Structural Inspection

Subject: Structural Inspection of Residential Slab
200 Legendre Dr.
Slidell, LA 70458

CROSS SECTION DETAIL

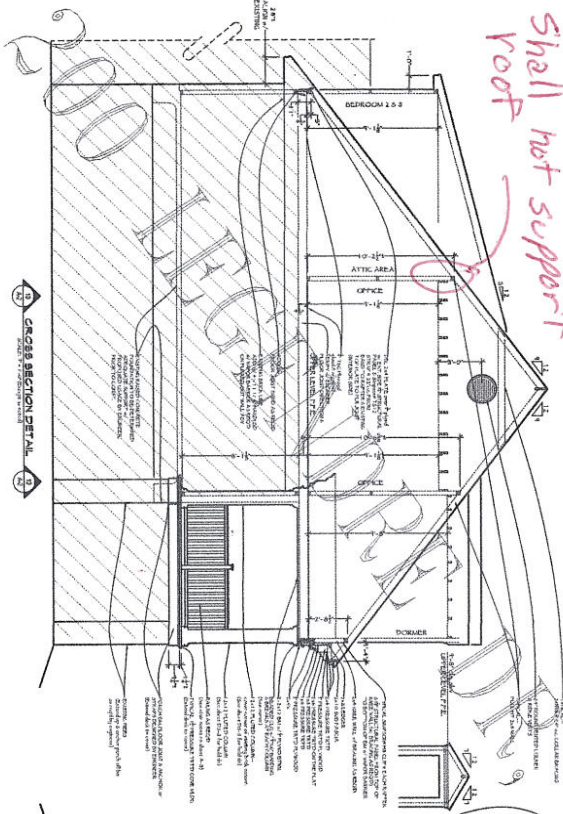
The reference drawings show that the new 1st floor load bearing walls are to be rebuilt in the same position where they were originally built. The additional steel beams with pipe columns under the northwest to southeast wall will support the load-bearing wall on the 1st floor as well as the loads from the 2nd floor, however will not support the additional loads and the roof system.

The reference drawings also show that some of the new 2nd floor walls do not sit directly over the 1st floor load-bearing walls.

The roof shall be supported only on the exterior walls, therefore transferring the roof load to the exterior concrete beams. The roof trusses shall be pre-engineered trusses and not stick built to ensure that no interior walls support the roof system or wind loads from the roof.

Additional support should be added to support the 2nd floor walls by doubling up on the 2x8 floor joist and ensuring that these double joists are directly under the 2nd floor wall(s) when running parallel.
